PLANNING COMMISSION

ITEM 1: SITE PLAN REVIEW

PROJECT LOCATION: 1180 N. CLINTON STREET, DEFIANCE, OH 43512.

Project Review Comments for 1180 N. Clinton Street
July 2025

C4.1
UTILITY PLAN

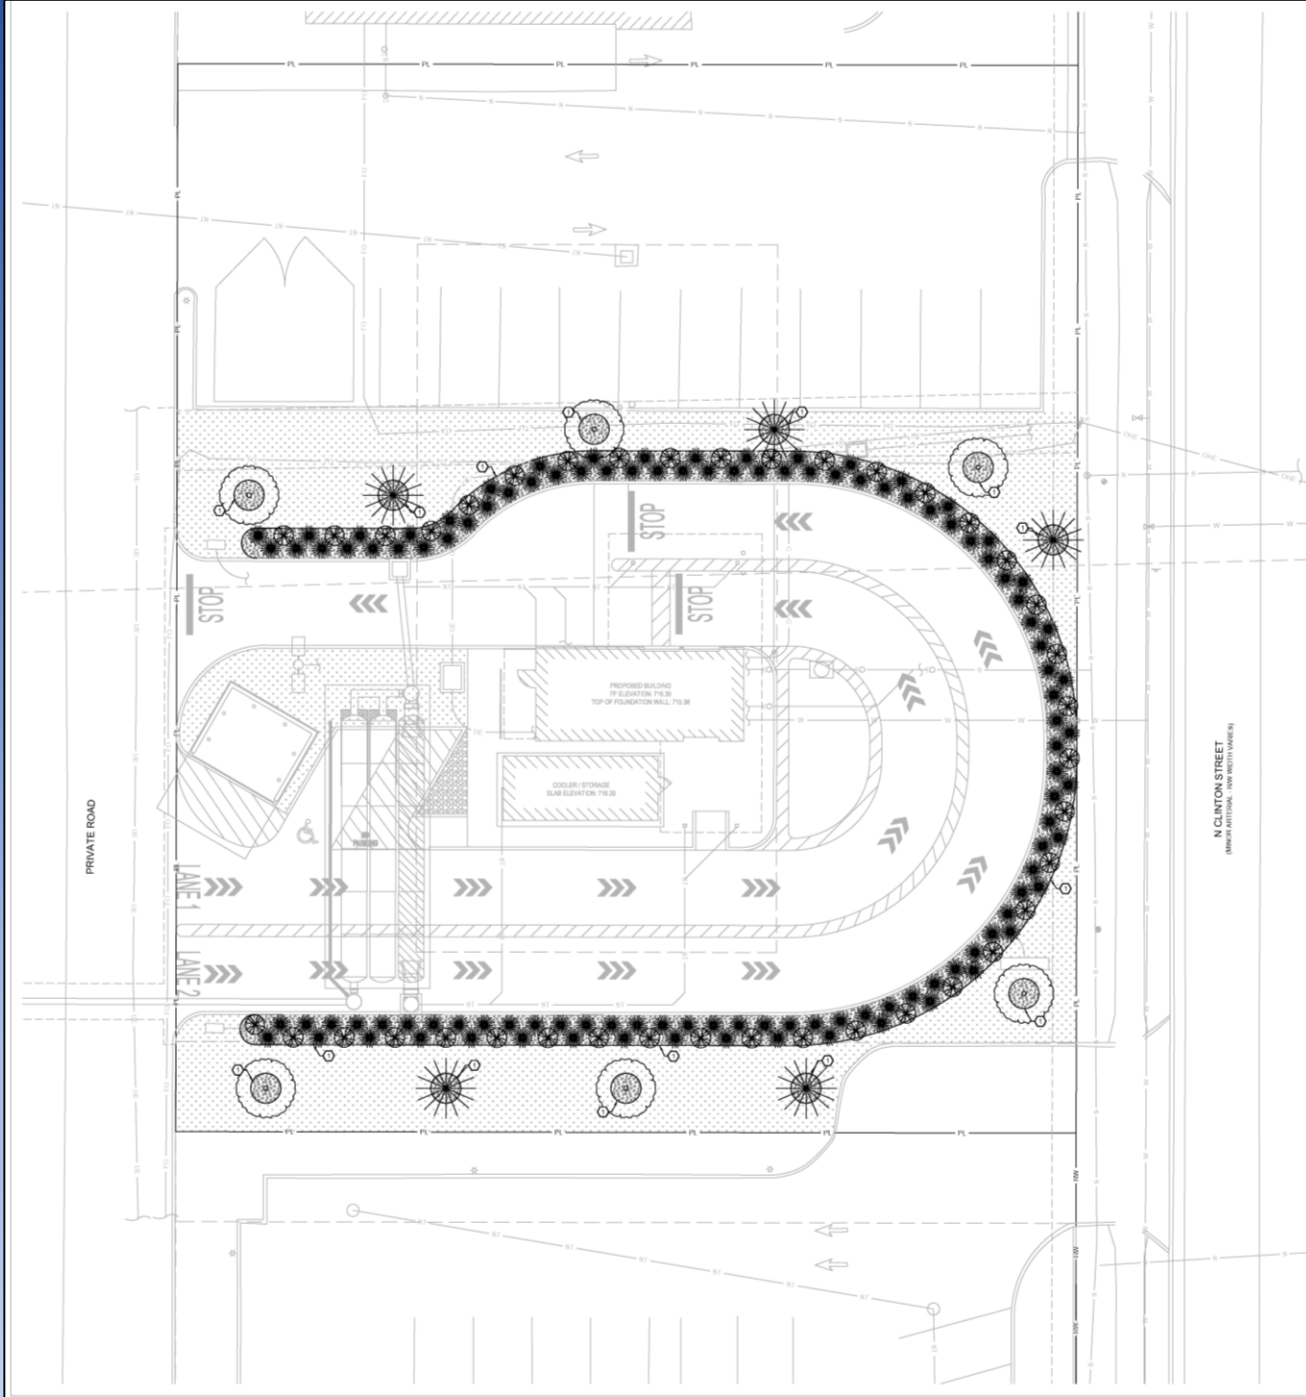
Division	Comments
Building & Zoning	Rex Robison, Building & Zoning Commissioner: No comments received.
Engineering	Melinda Sprow, P.E., City Engineer: <ul style="list-style-type: none">• Modify Address on Submittal to 1140 N Clinton• Provide drainage calculations• Provide detention calculations & long-term operation & maintenance document• Provide easement for storm drainage system per Planning & Zoning Code• Provide letter from property owner indicating they have approved the plans and will accept the storm drainage• Provide tie-in detail to sanitary sewer main• Additional comments to be provided at the conclusion of a full review of the construction drawings
Parks & Grounds	Rob Cereghin, Parks Director: No park issues.
Streets & Water Distribution	DJ Zeedyk, Streets Superintendent: I do not see a plumbing detail for meter and backflow for the coffee shop.
Water Pollution Control	Mark Lenhart, Superintendent, Water Pollution Control The Seven Brew Coffee drive thru has no food items so a grease trap is not needed. They will have to establish a sanitary lateral into the city sewer. This lateral tie in will require them to follow city requirements for sanitary laterals.

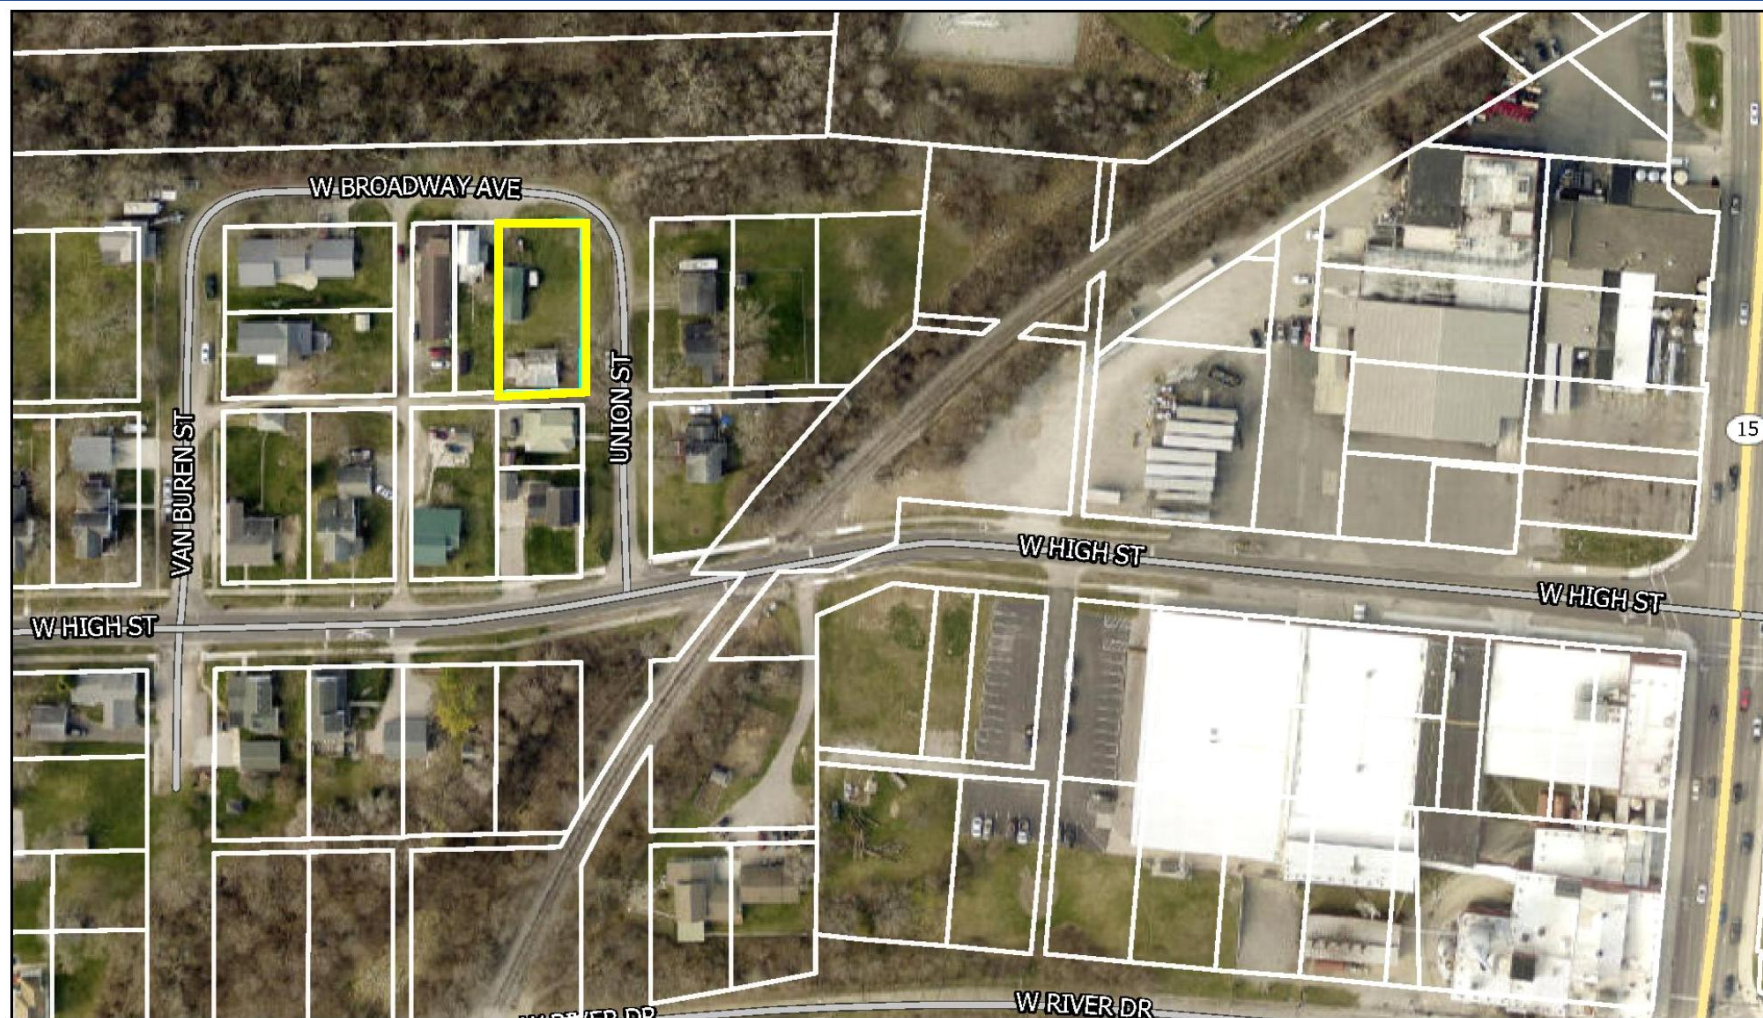
Division	Comments
Building & Zoning	Rex Robison, Building & Zoning Commissioner: Abstain from comment.
Engineering	Melinda Sprow, P.E., City Engineer: This applicant is proposing a Minor Subdivision to create two lots. The sanitary lateral crossing the southern parcel from the northern unit should be located in an easement. We will review the site plan for appropriate information when reviewing for the Engineering Certificate.
Parks & Grounds	Rob Cereghin, Parks Director: No park issues.
Streets & Water Distribution	DJ Zeedyk, Streets Superintendent: No issues from streets or water distribution.
Water Pollution Control	Mark Lenhart, Superintendent, Water Pollution Control For the duplex on Union St., there is no sewer on Union so the lateral will have to come out the south side of the property to the sanitary sewer located in the alley. If they are attaching to an existing sewer they need to follow the sewer use ordinance that requires the lateral to be inspected and approved for use.
